# **RIVERVIEW SUBDIVISION, RESUBDIVISION OF PART OF LOTS 14, 15, & 16**

APPLICATION NUMBER 10 DATE March 16, 2006

REQUEST Subdivision

## DETAIL SITE PLAN

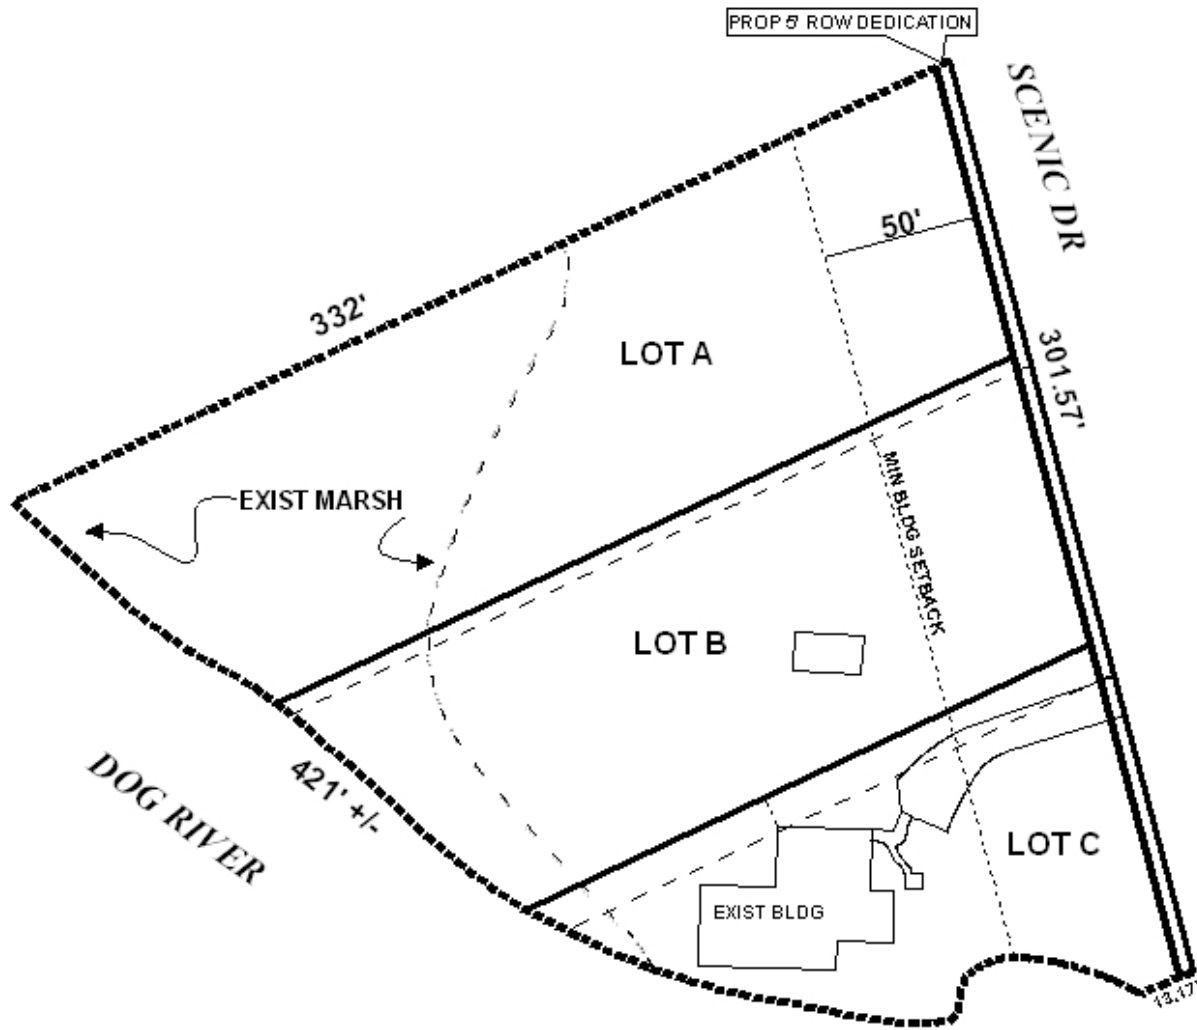
The site fronts Scenic Drive, which has a varying right-of-way; the plat illustrates 20 feet between the property and the centerline and the requisite dedication of 5 feet as well. The plat also illustrates a 50-foot setback from the dedication.

As the site contains wetlands and would be considered environmentally sensitive, approvals from federal, state and local agencies will be required prior to the issuance of any permits. Furthermore, the accessory structure on proposed Lot B should be removed prior to signing the final plat, since a lot cannot have an accessory structure without a primary structure.

The plat meets the minimum requirements of the Subdivision Regulations and is recommended for Tentative Approval subject to the following conditions: 1) approval by all applicable federal, state, and local agencies prior to the issuance of any permits; 2) removal of the accessory structure from Lot B prior to signing the final plat; and 3) the dedication of 5 feet from the centerline of Scenic Drive, as shown on the plat submitted.
